**Request for Additional Information No. 306, Question 03.08.01-39**

**U.S. EPR Standard Design Certification**

**Docket No. 52-020**

**Question 03.08.01-39:**

**Figure 03.08.01-39-1—Plot of Additional Thermal Demand against the Interaction Diagrams for Containment Wall Section**

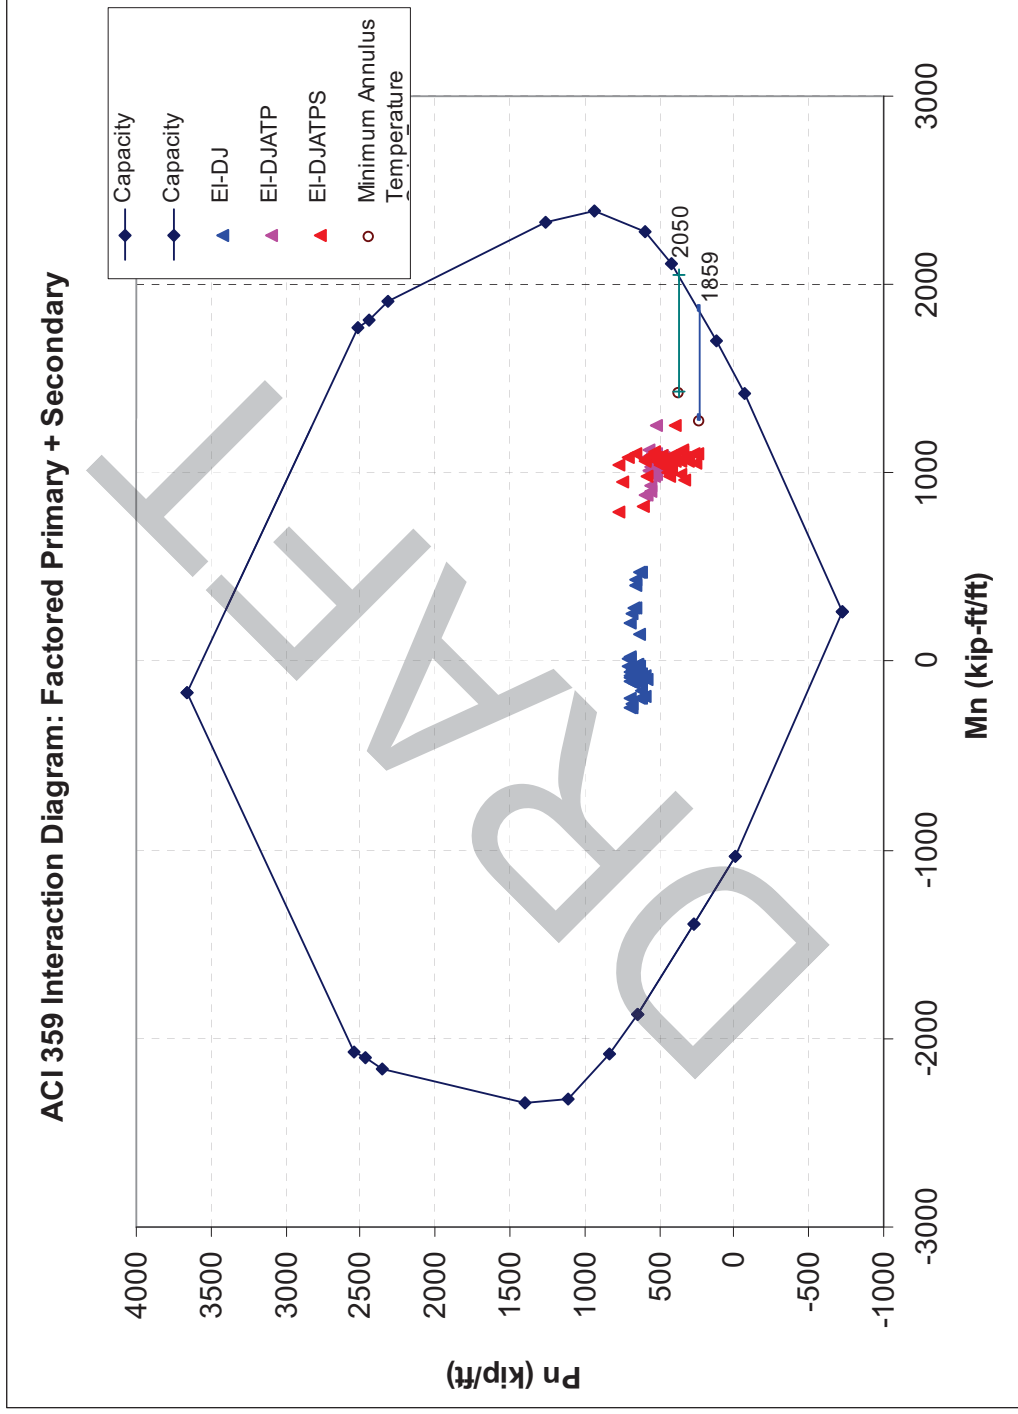
5. The response to RAI Number 3.8.1-14 states that the axisymmetric model of the RCB was also used to study the effect of the variations in the temperature of the annulus relative to the 79F value used to date, and that the results of this study would be given in the response to this RAI. Since the RAI response only marginally mentions this issue, provide a complete discussion on the results of this study.

The axisymmetric model of the RCB was used to study the variation of annulus temperatures ranging from a minimum of 45°F to a maximum of 113°F. The results at four critical time points from this study are the same time points used in the design of the RCB wall as described in U.S. EPR FSAR Tier 2, Section 3.8.1.4.4. The four critical time points were selected by choosing time points where maximum forces and moments occurred for

different sections of the RCB under accidental temperature and pressure distribution. In the parametric study, the results for the thermal analysis at these four critical time points indicate that the minimum annulus temperature of 45°F results in larger design forces and moments, while the maximum annulus temperature of 113°F results in a reduction of the design forces and moments in the RCB wall. However, the combination of the variation in thermal properties, mechanical properties, and annulus temperature has an insignificant effect on the resulting forces and moments of the RCB wall. U.S. EPR FSAR Tier 2, Section 3.8.1.4.4 will be revised to update the four time points used in the temperature and pressure analysis.

The parametric study shows that the variation in thermal and mechanical properties has an insignificant effect on the forces and moments that affect the RCB wall. The study shows that an increase in annulus temperature reduces the design forces and moments of the RCB wall which is conservative. However, a decrease in annulus temperatures, to minimum of 45°F, increases the design forces and moments as shown in Table 03.08.01-39-3 for the four selected critical time points.

The 45°F minimum annulus temperature concurrent with loss of coolant accident temperatures on the interior face of RCB is an extremely unlikely scenario. An annulus temperature of 45°F is only possible during an outage with the equipment hatch is open. The duration of the outage is typically 20 days in 18 months. Therefore, the additional thermal forces and moments at 45°F are unlikely to occur in the RCB wall.

Figure 03.08.01-44-4(a), in the response to RAI 335 Question 3.8.1-44, shows the additional capacity of the containment wall against the demand. Table 03.08.01-39-3 shows that the maximum thermal moment of 185 kip-ft/ft, along with the tensile axial force of 17 kip/ft, represents the worst case scenario for the additional thermal moment due to minimum annulus temperature (45°F). The extra thermal force and moments are added to the existing demand and plotted against the RCB wall capacity interaction diagrams in Figure 03.08.01-39-1. Figure 03.08.01-39-1 shows that there is sufficient section capacity (615 (=2050-1435) kip-ft/ft or 573(=1859-1286) kip-ft/ft) in the wall at the 45°F minimum annulus temperature. Therefore, design capacity shown in Figure 03.08.01-39-1 adequately envelopes the additional demand for the unlikely scenario of a 45°F minimum annulus temperature.
